CMD: 21-H6

McClean Lake Operation

**Licence Amendment for
the JEB TMF Expansion**

CNSC Staff

Figure 3.5: McClean Lake - Illustration of the designed embankment and liner system

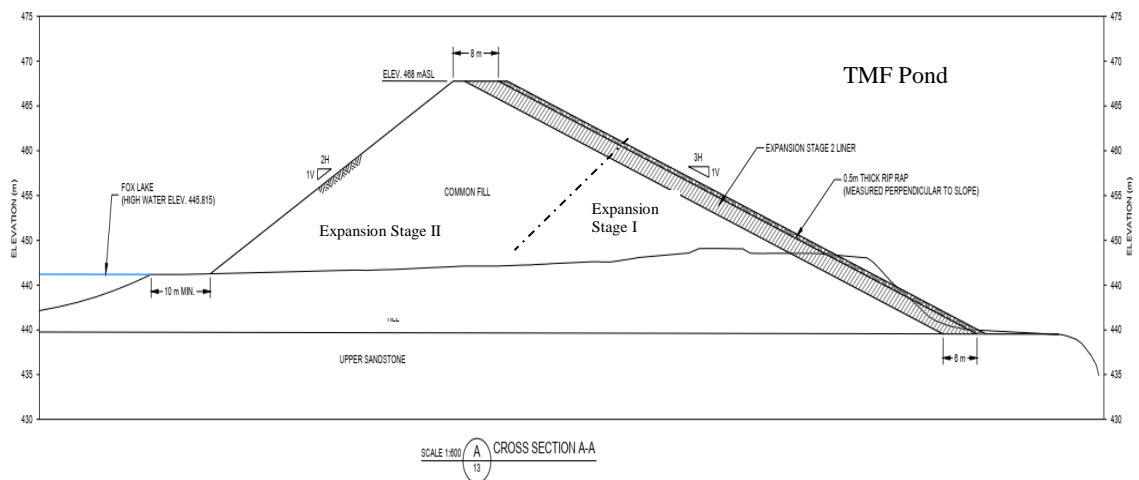
The designed embankment has an upstream slope of 3H:1V and a downstream slope of 2H:1V with a crest width of 8 metres. The section near the raise water pump house is designed with 2H:1V upstream slope (figure 3.6) to avoid impacting the raise water pump house and a section on the north side of the TMF is designed at 3.5H:1V to smooth the curve of the embankment crest. The toe of the downstream slope is 10 metres to the high water level at Fox Lake. The main body of the embankment will be constructed with compacted rock fill. A processed bentonite-amended crushed sandstone liner of 6 metres (measured horizontally) will be constructed on the upstream slope, which will be protected by a 0.5 metre (measured perpendicular to slope) thick riprap. As discussed in section 3.2.1, the calculated factor of safety (for deterministic analysis) and the reliability index (for probabilistic analysis) for the designed embankment meet the criteria for embankment slope stability.

- adequate geometry of the embankment, (e.g., no slopes steeper than a gradient of 2H:1V to ensure the required factor of safety)
- understanding of the role of groundwater and tailings water
- need for “Engineer of Record” for the expansion project
- adequate construction QC/QA to ensure the embankment to be constructed as designed
- proper instrumentation and monitoring plan to ensure the embankment structure integrity during construction and operation
- understanding of potential consequence of unlikely accidental embankment failures.

A pond wave analysis was conducted to calculate the freeboard requirement and determine the size and thickness of a riprap layer required to protect the liner slope from wave action. As such, a 1 metre freeboard would be sufficient to meet the freeboard requirement and a 0.5 metre (measured perpendicular to slope) thick riprap will protect the liner from wave action, as shown in figure 3.5.

Figure 3.7: McClean Lake - Illustration of proposed landform for decommissioned JEB TMF

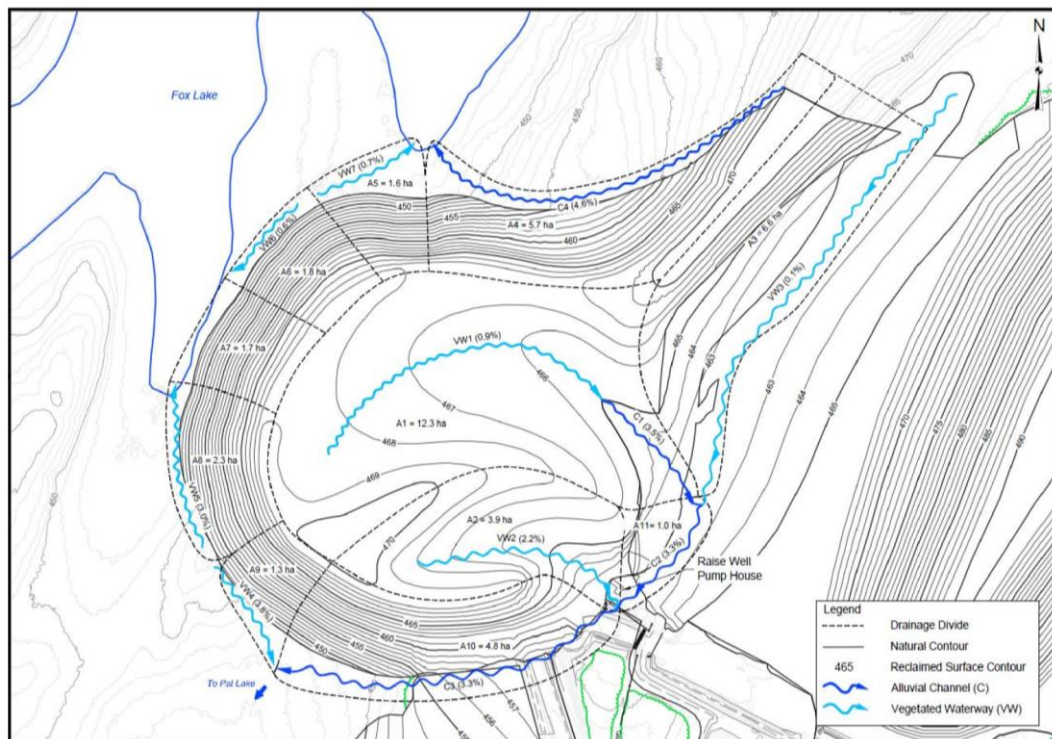
Figure 3.7 presents a preliminary landform design for the decommissioned JEB TMF based on the physical characteristics of natural landforms and hydrologic simulations of the flow conveyances in the drainage channels and waterways. During the assessment, CNSC staff were concerned regarding Orano's use of a flood event resulting from 1:100 year rainfall in consideration for the drainage channel and waterway design. This assessment cannot guarantee that no major erosion would occur on the decommissioned TMF landform over the long term. CNSC staff were also concerned regarding the proposed decommissioned embankment slopes of 4H:1V as no sufficient evidence was provided to demonstrate that a 4H:1V slope would have enough erosion resistance to ensure no major erosion would occur over the long term. In response, Orano has agreed to use the probable maximum flood event for the detailed design of the drainage channel and cover in addition to consideration of potential climate change effect on the design. Orano has also agreed that the detailed design of the cover will further assess erosion on embankment slopes and assess the need for refinement. This refinement could include flattening surface gradients and/or drainage distances of the decommissioned TMF slopes to meet the design criterion of "permanent walk-away closure", taking into consideration that the decommissioned JEB TMF is a tailings disposal facility and not a natural drumlin feature.

CNSC staff concurred with the approach used for landform design and have accepted the preliminary landform design. The licensee will provide the final detailed closure landform design prior to the decommissioning of the JEB TMF. CNSC staff will review the landform design and provide recommendations to the Commission for approval as part of an overall licensing decision by the Commission, which is required before Orano can begin decommissioning activities. This design will incorporate the final cover design, climatologic and hydrologic conditions, environmental features of the site, and best science available at the time of decommissioning. This final landform design would ensure the long-term integrity and the environmental performance of the decommissioned JEB TMF.

Figure 3.8: McClean Lake - Preliminary design of the TMF soil cover

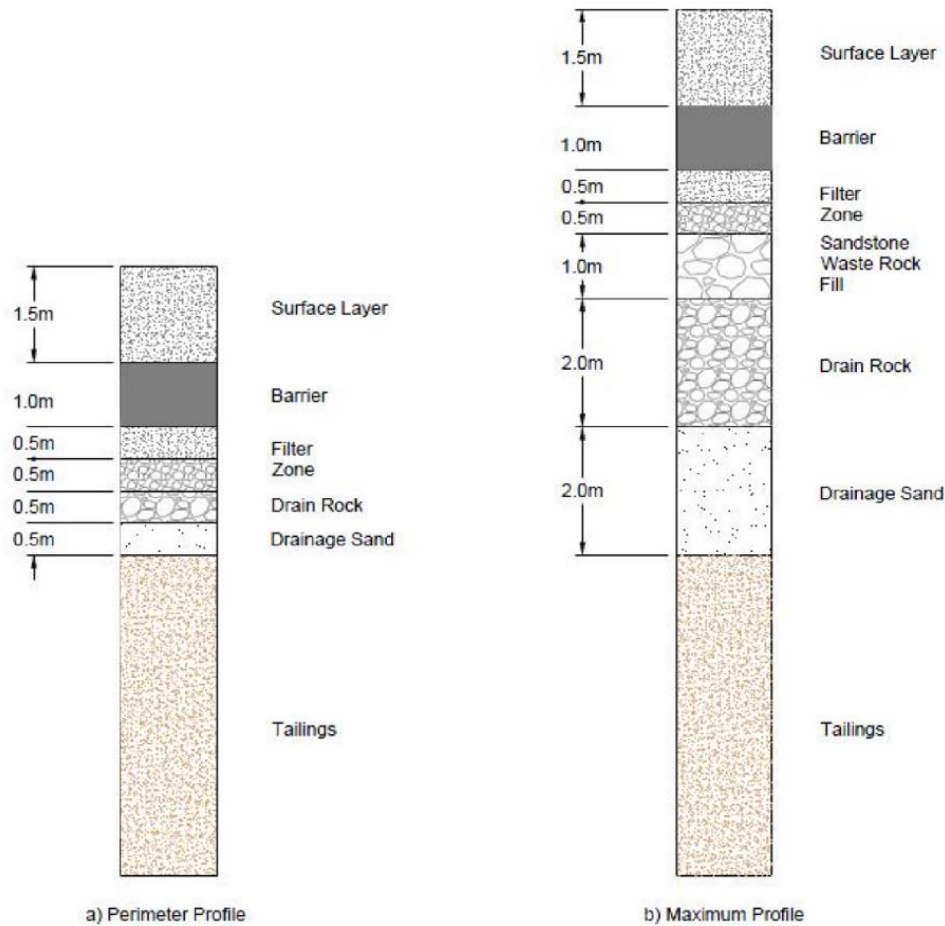
As shown in figure 3.8, the current soil cover design is preliminary and intended to demonstrate the feasibility of the construction of a soil cover to limit net percolation (NP) to the values, if required, to ensure the overall performance of the decommissioned TMF. The cover design requirements will be refined through the detailed design process considering the results of a field cover test plot program and the analysis of overall JEB TMF performance through the TOVP. CNSC staff accepted the preliminary cover design for the purpose of demonstrating the feasibility of the construction of a soil cover to limit NP to the values that can ensure the overall performance of the decommissioned JEB TMF. CNSC staff expect that the detailed final cover design be completed prior to decommissioning of the JEB TMF to ensure the long-term cover integrity and minimize the reliance on active institutional controls post closure. Orano has agreed to develop a detailed soil cover performance monitoring program prior to decommissioning of the JEB TMF, including performance indicators, to monitor the soil cover performance post decommissioning to confirm/verify that the cover is performing as designed.

Orano has agreed to provide a detailed cover design and a detailed landform design prior to decommissioning of the JEB TMF. The detailed designs will be supported with further analyses and arguments to ensure their long-term integrity and the expected environmental performance.

Figure 3.1: Mass flux of COPCs to Fox Lake versus time [3]

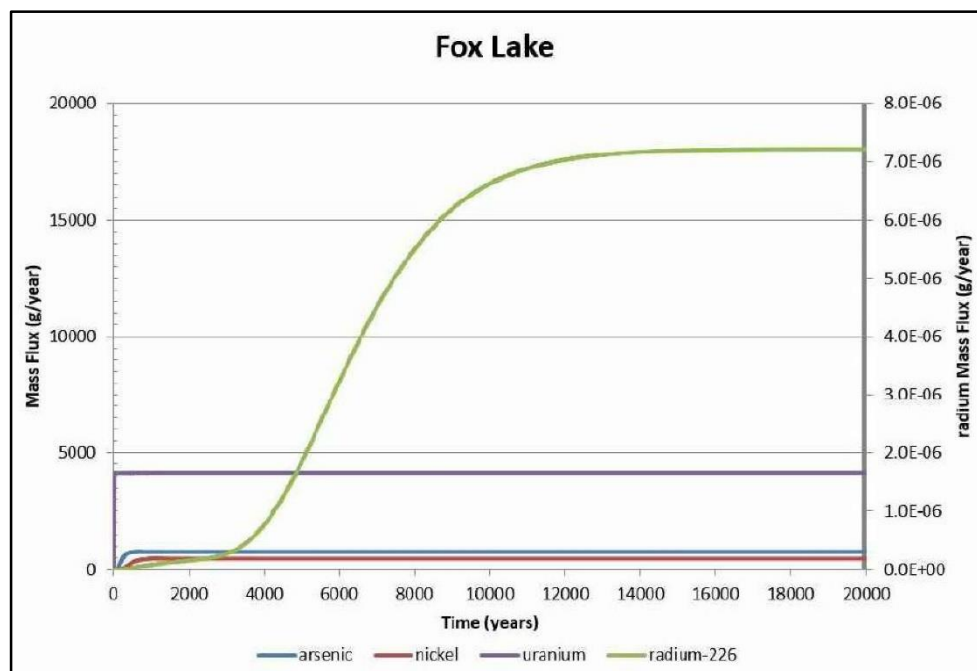
The groundwater discharge from the expanded JEB TMF after decommissioning is anticipated to migrate west and south towards Fox and Pat Lakes, respectively. Orano modelling predicts approximately 70% and 30% of the groundwater flow will discharge to Fox Lake and Pat Lake, respectively, however, 100% of the flow will ultimately reach Pat Lake since Fox Lake flows into Pat Lake. Figure 3.1 displays Orano's predicted mass flux or movement of arsenic, nickel, uranium and radium-226 to Fox Lake via groundwater over time. The migration of COPCs via groundwater to surface water will occur over various time periods based on their mobility, attenuation and decay characteristics, and on advective and diffusive transport mechanisms. Movement of COPCs from the JEB TMF to groundwater and subsequently to surface water will continue for hundreds to thousands of years after decommissioning [3]. This slow movement of contaminants in groundwater to surface water was simulated and the predicted surface water concentrations were considered to meet decommissioning criteria for the currently approved JEB TMF, and will occur in a similar way over a similar time frame for the expanded JEB TMF. A sensitivity analysis of the modelled mass COPCs loading rates to groundwater noted that the rate of precipitation infiltrating through the engineered cover and the pore water concentrations of the COPCs had the most influence on the predicted mass flux or movement of COPCs from the JEB TMF into groundwater [3].

CNSC staff reviewed Orano's post-decommissioning predictions of groundwater discharge and contaminant transport modelling in the JEB TMF Expansion (468 mASL) Notification and Project Description [3] and found them acceptable. However, given the very long time frame associated with the predictions, CNSC staff requested that groundwater quality be monitored after decommissioning to track the fluxes of unattenuated COPCs, such as chloride and sulphate, from the closed and decommissioned JEB TMF to groundwater to provide an early indication of the accuracy of the flux predictions.

Pending Commission approval of the project, Orano has agreed to monitor groundwater quality at wells close to the JEB TMF to provide an early performance indicator of the contaminant plume migration, the groundwater COPC concentration predictions and the long-term COPC concentration predictions in Fox Lake and Pat Lake. If the revised COPCs predictions in Fox Lake and Pat Lake water are above the current long-term assessment predictions, Orano has committed to assess risks to the receiving environment and if necessary, implement mitigation measures [23].

Figure 3.2 Cross-Section through the Preliminary Design for the Soil Cover [3]

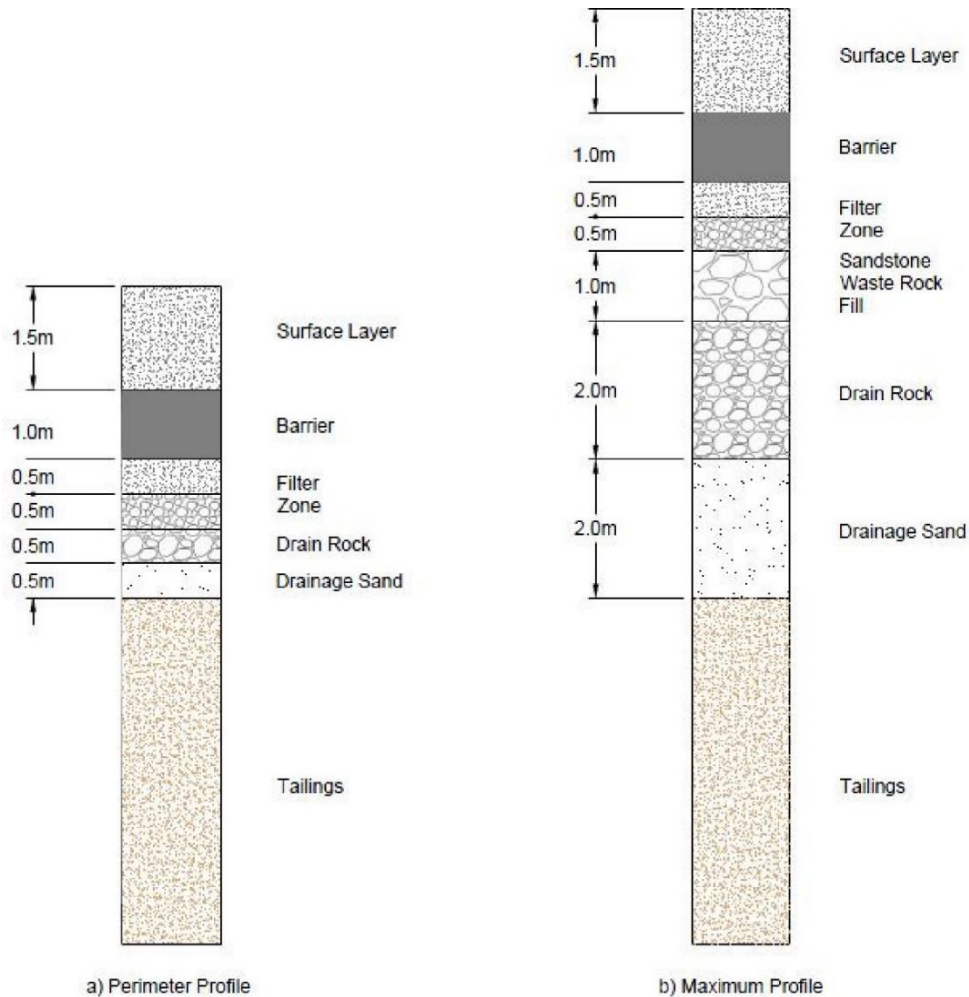
Cross sections through the preliminary design for the proposed soil cover are displayed in figure 3.1. The preliminary design is for the constructed cover to range in depth from 4.5 m at the perimeter of the facility to a maximum of 8.5 m in the centre and to be composed of drainage sand, drain rock and sandstone waste rock fill, a filter zone, an engineered barrier and a surface layer of soil. The proposed engineered barrier will be a mixture of crushed sandstone and bentonite clay to limit the percolation or infiltration of precipitation into the waste. Orano will construct and monitor test cover plots while the JEB TMF is operating to assess the efficacy of the proposed cover design and use the results of the test cover plots to enhance or refine the cover detailed design.

[15]. Regardless, Orano provided a Cover Erosion Assessment [15] whereby they considered a hypothetical case of a discrete, beyond design basis erosion event of sufficient concentrated flow that would result in the formation of a V-shaped gully 6 m wide and 3 m deep in the major surface drainage channels in the proposed closed landform. Orano considered this an extreme bounding case for the performance of the cover over the long term. The assumption of 3 m of erosion into the cover would result in the loss of the engineered barrier layer (a mixture of crushed sandstone and bentonite clay) and therefore infiltration of precipitation through the drainage channels would increase to 100 mm/year in the area of the drainage channels only. Orano calculated the formation of a V-shaped gully and accompanying erosion would result in an increase in infiltration rate from 10 mm/year to 12 mm/year over the entire closed JEB TMF surface.
